Access Compliance Report

Public Rights-of-Way

(Curb Ramps)

Intersection ID: 2897	Main Street: BELL'S_MILL_DR	Cross Street: HARBURN_FOREST_DR	Location: SW
ADA ID: 699A03E7DDCC	Ramp Type: PerpDiag	Initial Pass/Fail: Fail	Overall Compliance: No
Severity Score: 26.25			
Codes/Mitigation Info/Possible Solution		Field Measurements/Component Compliance

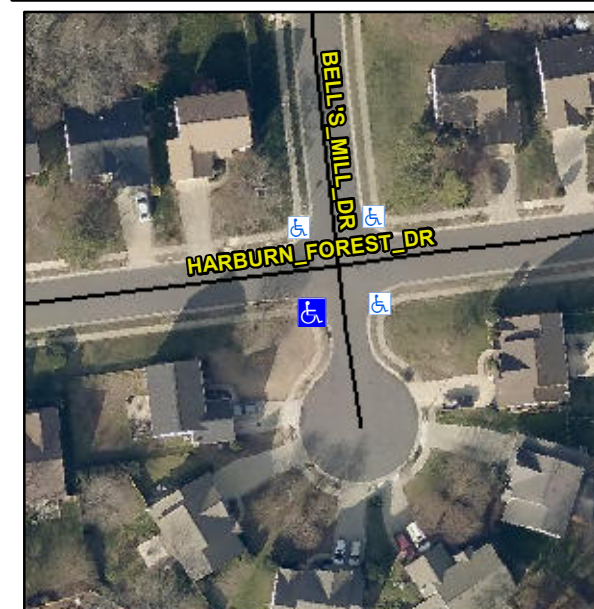
Not Found, R304.2.2, R304.5.3

Compliance	Description	Data	Compliance	Description	Data
N/A	Ramp Length (in)	48.0	No	Ramp Slope (%)	20.8
Yes	Ramp Width (in)	48.0	No	Ramp XSlope (%)	3.0
N/A	Flare Type LT	N/A	N/A	Flare Type RT	N/A
N/A	Flare Slope LT (%)	N/A	N/A	Flare Slope RT (%)	N/A
N/A	Flare Traversable LT?	N/A	N/A	Flare Traversable RT?	N/A
N/A	Landing Length (in)	N/A	N/A	DWS Provided?	N/A
N/A	Landing Width (in)	N/A	N/A	DWS Contrast?	N/A
N/A	Landing Slope (%)	N/A	N/A	DWS Length (in)	N/A
N/A	Landing X Slope (%)	N/A	N/A	DWS Full Width?	N/A
N/A	Landing Curb? (Y/N)	N/A	N/A	DWS Offset (in)	N/A
N/A	Shared Landing?	N/A			
N/A	Gutter Ponding?	N/A	N/A	Gutter Slope (%)	N/A
N/A	Gutter Lip Ht (in)	N/A	N/A	Gutter X Slope (%)	N/A
N/A	Painted X Walk1?	No	N/A	Painted X Walk2?	No
	X Walk 1 Direction	To E		X Walk 2 Direction	To N
N/A	X Walk 1 Width (in)	N/A	N/A	X Walk 2 Width (in)	N/A
	X Walk 1 Slope (%)	0.9		X Walk 2 Slope (%)	4.1
	X Walk 1 X Slope (%)	0.1		X Walk 2 X Slope (%)	2.5

Remove & Replace Curb Ramp With Two New Directional Ramps or Equivalent.
